Peer Review of Proposed Float Size for Sausalito Ferry Terminal Improvement Project – Summary Report

COWI was retained by the City of Sausalito in May 2016 to perform a Peer Review of the Golden Gate Bridge Highway and Transportation District's (District) proposed float for the Sausalito Ferry Terminal Improvement (Project). The Peer review consisted of two phases.

Section 3 - Conclusions on if the float dimensions are optimized

Figure 1 – Plan View of Float and Walkways

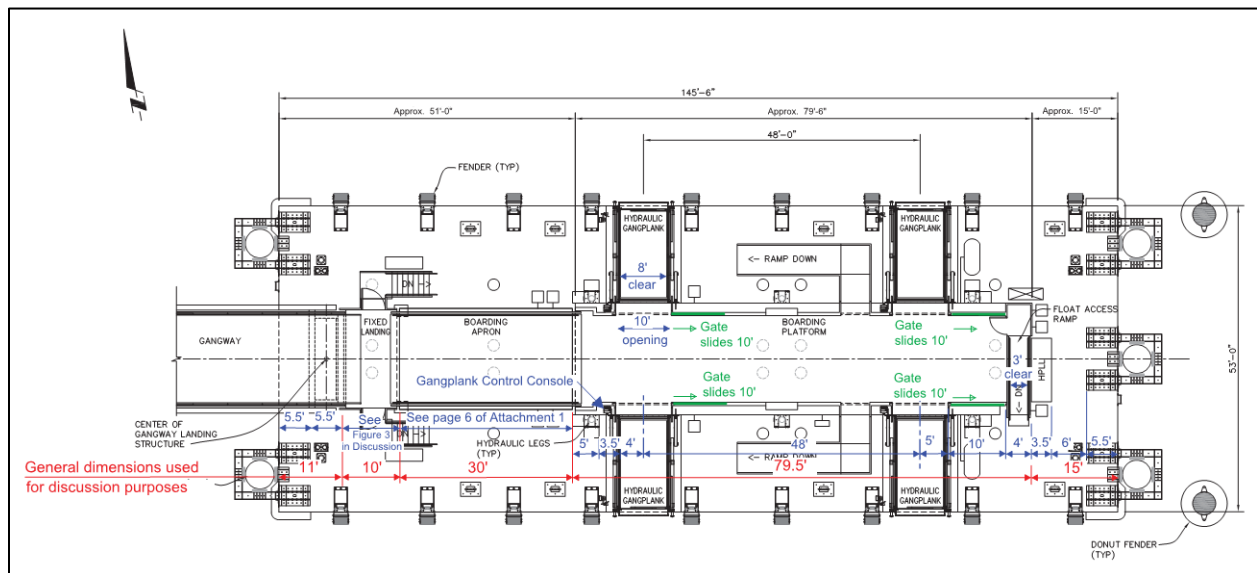
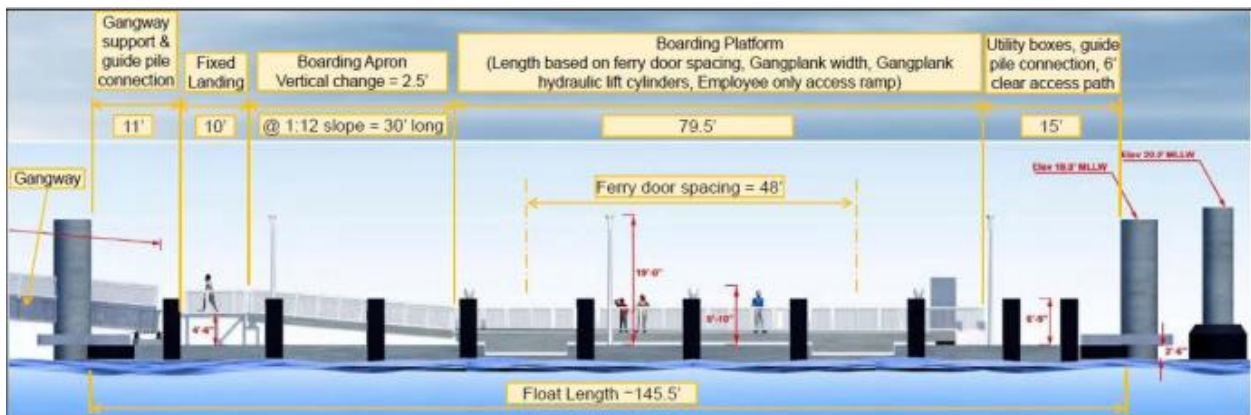
Float Length (145'-6")

The proposed 11'-0" Near End of the float consists of 5.5' of space for workmen to access the gangway rollers/pins for maintenance/repair and 5.5' for the gangway support structure. The details and assumptions of the District with respect to the 5.5' gangway support structure appear reasonable.

It appears that the 5.5' worker access space could be optimized based our review of the available information. This distance could be reduced by approximately 1ft.

In the response provided on July 14, 2016 the District indicates that "*the 5.5' worker access space is necessary for access and safety purposes.*" COWI has not been able to independently verify the need for 5.5' width for safety reasons. Typically safety requirements are established by the owner/end users in addition to governing regulatory agencies (California Building Code, OSHA, etc.). In this situation, the "safety reasons" appear to be an owner/end users requirement and COWI cannot offer a definitive conclusion on the provided width.

b. Fixed Landing (10'-0")

The proposed 10.0' Fixed Landing provides a flat transition between the Gangway and Boarding Apron. Although only 5.0' is required per ADA requirements, the 10.0' must include transition plates between the flat Fixed Landing and varying slopes of the Gangways and Boarding Aprons. The details and assumptions of the District with respect to these plates and other design constraints such as gaps at hinges appear reasonable. It is our conclusion that the Fixed Landing length is optimized.

c. Boarding Apron (30'-0")

The proposed 30.0' Boarding Apron length must accommodate 2.5' of vertical movement and is controlled by ADA requirements that slopes must not exceed 1:12. Our independent calculation confirms the 30.0' length. It is our conclusion that the Boarding Apron length is optimized.

d. Boarding Platform (79'-6")

The proposed 79.5' Boarding Platform length chiefly accommodates the spacing of the existing ferry doors (56.0' from the outside of the near door to the outside of the far door), 10.0' to store the rolling gates when passengers are disembarking and/or boarding the ferries, and 4.0' for an employee ramp (note that stairs cannot be used since the Boarding Platform moves up and down). The remaining 9.5' of length is occupied by hinge connections, hydraulic connections, gangplank consoles, etc. The details and assumptions of the District, along with our independent calculations support the 56.0' dimension. The 4.0' and 9.5' lengths appear to be reasonable. The 10.0' space provided to store the rolling gate could be optimized if the solid rolling gate was changed to a fabric mesh gate similar to the system used at the San Francisco Downtown Ferry Terminal Gate E, see Figure 3. The fabric mesh does not require significant space for storage, and the 10.0' space currently proposed could be reduced by 2 to 6 feet.

e. Far End - Utility Boxes, guide pile connection, 6' clear access path (15'-0")

The proposed 15.0' Far End of the float consists of 3.5' for hydraulic power units (HPU's), a 6.0' worker walkway and 5.5' for the guide pile collar connection to the float. The details and assumptions of the District with respect to the 3.5' width for the HPU's and 5.5' guide pile collar connection appear reasonable.

It appears that the 6.0' worker walkway space could be optimized based our review of the available information. Doors can be specified for the HPU's that open a full 180 degrees rather than 90 degrees and therefore do not obstruct the walkway. By eliminating the obstruction caused by the HPU doors would allow for the 6.0' worker walkway to be reduced by approximately 1 to 2 feet.

In the response provided on July 14, 2016 the District indicates that *"the 6.0' of clear worker access width is the minimum necessary for operational and safety purposes."* COWI has not been able to independently verify the need for 6.0' width for safety reasons. Typically safety requirements are established by the owner/end users in addition to governing regulatory agencies (California Building Code, OSHA, etc.). In this situation, the "safety reasons" appear to be an owner/end users requirement and COWI cannot offer a definitive conclusion on the provided width.

Float Width (53'-0")

The proposed float width of 53.0' is composed of the central walkway and gangplanks on either side of the walkway.

a. Central Walkway (16'-0")

The central walkway (Boarding Platform, Boarding Apron, Landing Platform and Gangway) provides access to and from the vessel to shore. COWI reviewed the District's rational for having a 16.0' walkway. The width is based on having two eight foot paths of travel feeding each of the 8.0' doors (8.0' door/path + 8.0' door/path = 16.0' walkway). The District maintains that the consistent 16' walkway is needed to maintain the District's preferred schedule. COWI has reviewed the District's calculations used to determine the 16' width and have provided comment in Section 4. The calculations indicate that the width of the central walkway may be able to be optimized by 2 feet while maintaining the District's preferred schedule.

b. Gangplanks (18'-6" x 2 Sides)

The gangplanks are located on each side of the central Boarding Platform. The 18.5' gangplanks are designed to be raised to meet high-freeboard catamarans or lowered to meet low-freeboard Spaulding class vessels. The slopes of the gangplanks must not exceed 1:12 per ADA for either vessel. Our independent calculation confirms the 18.5' length. It is our conclusion that the Gangplank length is optimized.

Figure 1

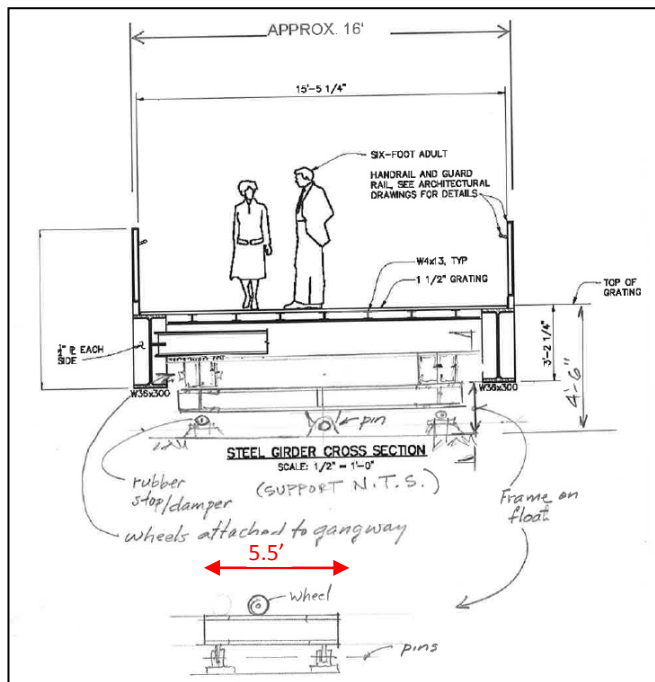
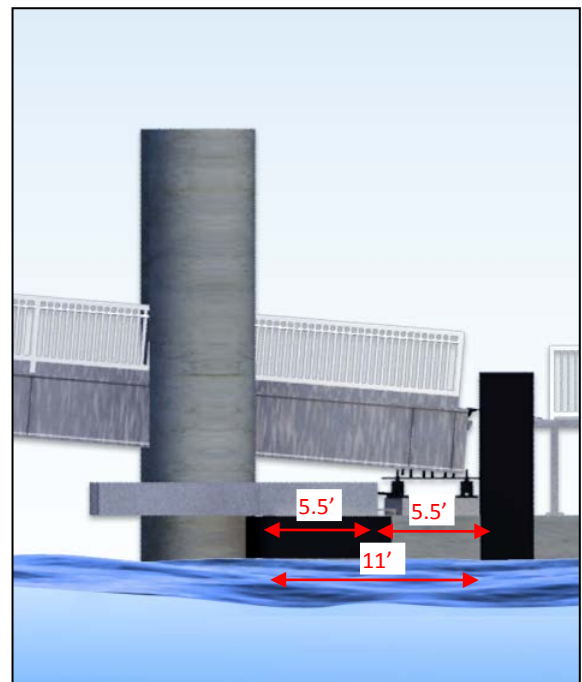
- 2. 11.0' feet is provided under the float end of the gangway for: the gangway support frame, maintenance access and the guide pile collars. Please clarify if this distance can be optimized. Information was received on May 16, 2016 and June 16, 2016 but more clarity and detail is requested.

2.2) *The Near End of the float consists of 5.5' of space for workmen to access the gangway rollers/pins for maintenance/repair. It is our opinion that the 5.5' of worker access space could be optimized. This distance could be reduced by approximately 1ft.*

A: The gangway support frame design has not been finalized but the general expected design is shown in Figure 1. The gangway is fixed on the access pier and is supported by rollers on the float. Due to the variability of the tides and waves, the design must have moving parts, as it will be necessary for the gangway landing to move with the float longitudinally and transversely. Based on preliminary engineering judgment, the preliminary gangway support frame design allows the gangway rollers/wheels approximately 3'-3" of movement to accommodate tide changes, extreme storm conditions, and unexpected high waves. The gangway rollers/wheels in the longitudinal direction must remain between the two pins as shown in Figure 1. Therefore, in order to accommodate for this movement and to provide the structural framing, the gangway support distance has been set at 5.5'. The District will need to access the gangway support for inspection and maintenance of the rollers and pins. For employee safety, the District has determined that a minimum of 5.5' in front of the gangway support is required along the float length to allow for at least 2 employees with their equipment to service the gangway support and to stay a safe distance away from the float edge. See Figure 2 for the 5.5'+5.5'=11.0' referenced. Also, see page 1 on Attachment 1 for the referenced dimensions along the overall float length.

The District maintains that the 5.5' worker access space is necessary for access and safety purposes. As shown in Figures 1 and 2 of the June 30, 2016 "Additional Proposed Float Information for City of Sausalito Peer Reviewer", a worker would need to crawl under the 3-foot deep steel girders to access the gangway support frame for inspection,

maintenance and repairs. Once under the gangway, there would be insufficient head room for a worker to stand up. For worker safety, we believe 5.5' is the minimum distance for two workers with their equipment to work around each other in the limited space provided under the gangway.

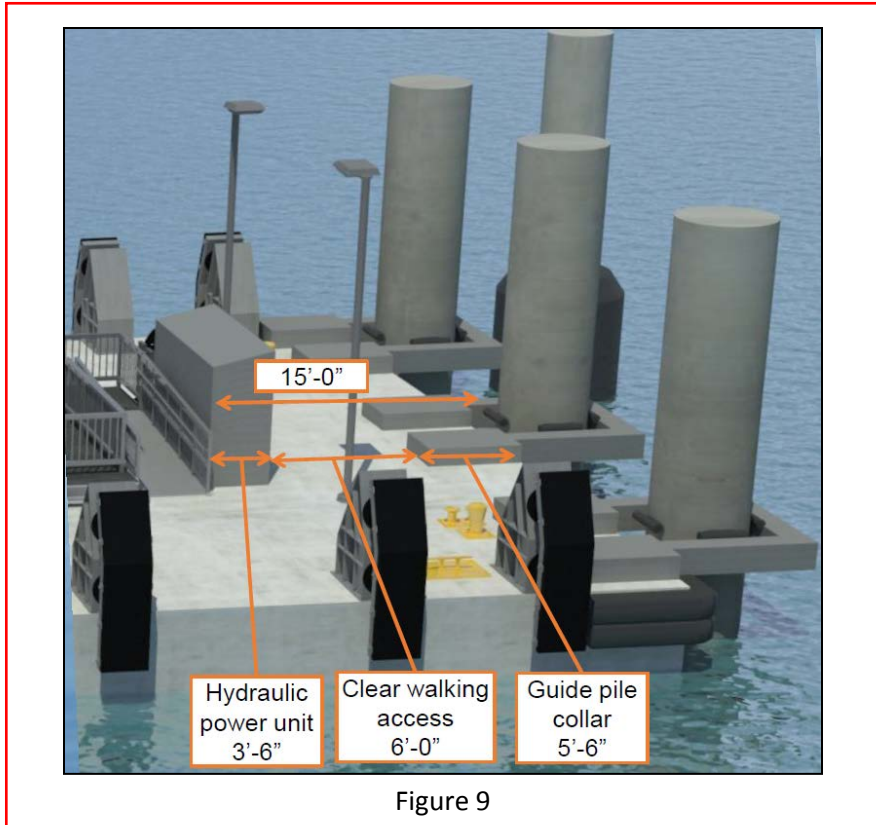
5. 15.0' is provided at the end of the float for the guide pile collars, utility boxes and a 6.0' access path (Ref. A: page 5 of 7 first paragraph, Figure 7, Drawing S1.2). Information was received on May 16, 2016 and June 16, 2016 but more clarity and detail is requested.

5.1) The proposed 15.0' Far End of the float consists of 3.5' for hydraulic power units (HPU's), a 6.0' worker walkway and 5.5' for the guide pile collar connection to the float. It is our opinion that the 6.0' worker walkway space could be optimized. Doors can be specified for the HPU's that open a full 180 degrees rather than 90 degrees and therefore do not obstruct the walkway. By eliminating the obstruction caused by the HPU doors would allow for the 6.0' worker walkway to be reduced by approximately 1 to 2 feet.

A: This distance has been re-evaluated and optimized to the extent possible. The hydraulic power unit required to operate the boarding apron and gangplanks is 3.5' wide. A 6' wide clear walking path is considered minimum for worker safety. This assumption is based on 2 maintenance workers with their equipment (such as a small cart) servicing the hydraulic power unit (there are 3 doors on the hydraulic power unit, each swing 3'). Adjacent to the 6' clear walking path is the 5.5' long guide pile collar necessary to connect the float to the guide piles to hold the float in place. The guide pile collar is a tripping hazard for employees and a safe walking area needs to be provided away from the guide pile collars. $3.5' + 6' + 5.5' = 15'$ shown in Figure 9 is the necessary distance along the float length for the hydraulic power unit, safe walking/working path, and the guide pile collar. See page 1 on Attachment 1 for the description of these items along the entire length of the float.

The District maintains that the 6.0' of clear worker access width is the minimum necessary for operational and safety purposes. This end of the float is heavily used on the existing float and multiple workers are simultaneously working in this area. The existing float allows for a minimum of 17' clear width at this end of the float. Hoses, ropes, etc. are currently used at this end of the existing float and are expected to also be used in the same location on the proposed float. When servicing the HPU, a person will still be occupying a space at least 3 feet wide in front of the unit. Reducing the clear width as suggested will not allow other staff to safely pass behind the person working on the unit. The District will not compromise worker safety by reducing the 6 foot clear width at this location.

OFF-LOADING - 16' GANGWAY & BOARDING PLATFORM WIDTH

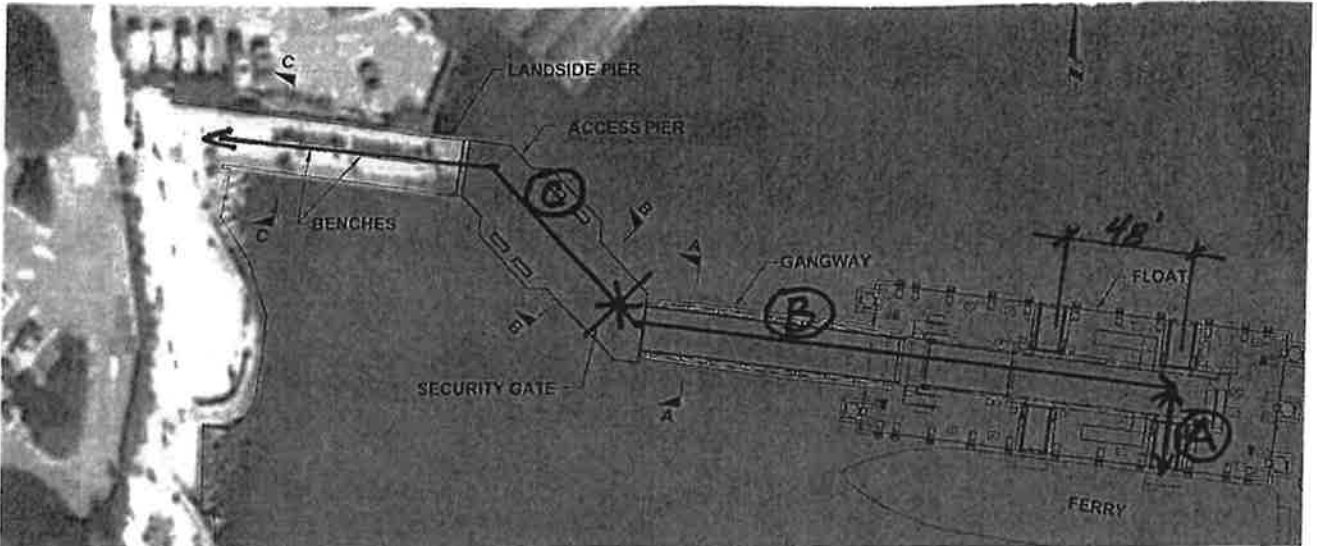
COWI reviewed the calculations provided by the District and also checked the boarding times if the width is further reduced to 10-foot. Our primary comment is that the off-loading and boarding time calculations are not consistent with the previous calculations from Carolina Wallin's memo dated June 30, 2016. To summarize:

- In the June 30, 2016 memo the off-loading and boarding times are calculated as the time it takes for passengers to pass through the ferry doors plus the time it takes for the passengers to walk to/from the ferry doors to the landside security gate. The time calculation to pass through the ferry doors explicitly includes the 8-foot width of the ferry doors while the time calculation to walk to/from the ferry doors from the landside security gate does not explicitly include the width of the walkways.

- In the August 11, 2016 memo the off-loading and boarding times are calculated for 14-foot and 12-foot walkways and compared to the time for the 16-foot walkway. The August calculations assume that the width of the 8ft ferry doors and hydraulic gangplanks have been reduced when only the width of the gangway, fixed landing, boarding apron and boarding platform should be reduced. The District ratioed the ferry doors and hydraulic gangplank widths using the same ratioed reduction applied to the central walkway width. This ratioing is incorrect as the ferry doors and hydraulic gangplank have not changed in each of the scenarios.

- If these discrepancies are corrected it appears that the extra turnaround time for a terminal with 14-foot and 12-foot walkways (and two 8-foot ferry doors and two 8-foot hydraulic gangplanks) is 0.4 minutes and 0.9 minutes respectively.
